Innovative Request:

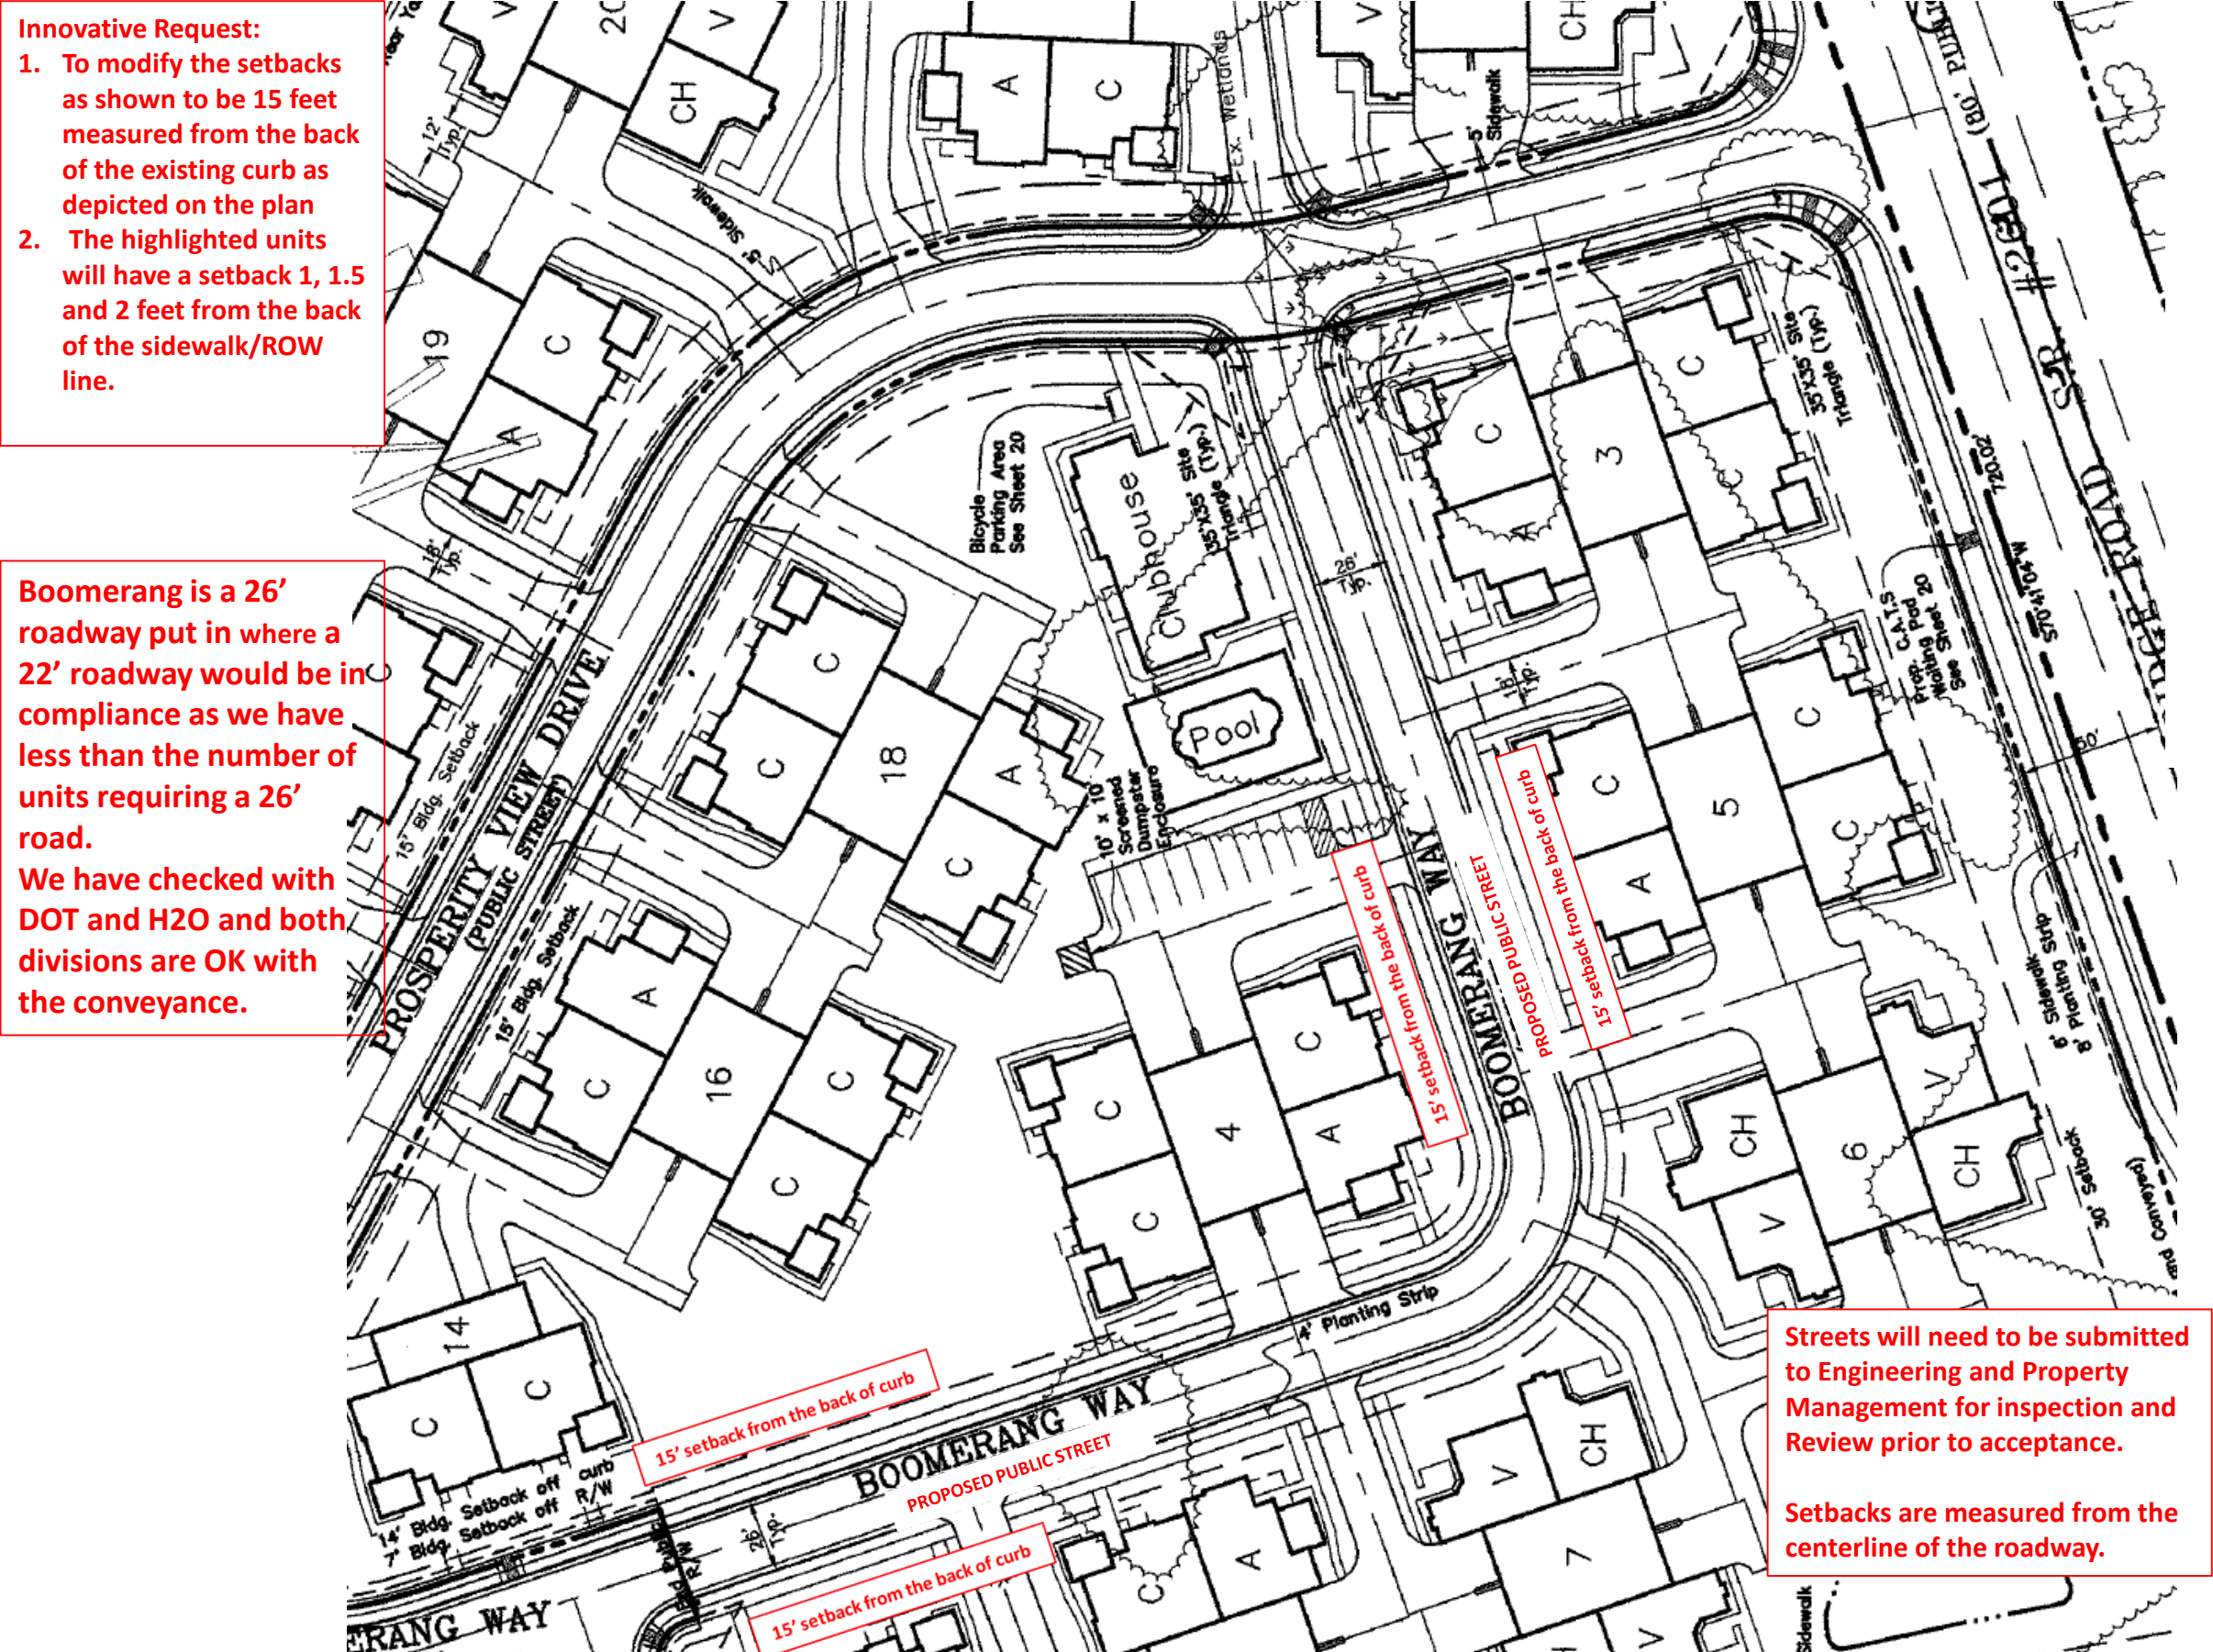
- 1. To modify the setbacks as shown to be 15 feet measured from the back of the existing curb as depicted on the plan**
- 2. The highlighted units will have a setback 1, 1.5 and 2 feet from the back of the sidewalk/ROW line.**

Boomerang is a 26' roadway put in where a 22' roadway would be in compliance as we have less than the number of units requiring a 26' road.

We have checked with DOT and H2O and both divisions are OK with the conveyance.

Streets will need to be submitted to Engineering and Property Management for inspection and Review prior to acceptance.

Setbacks are measured from the centerline of the roadway.
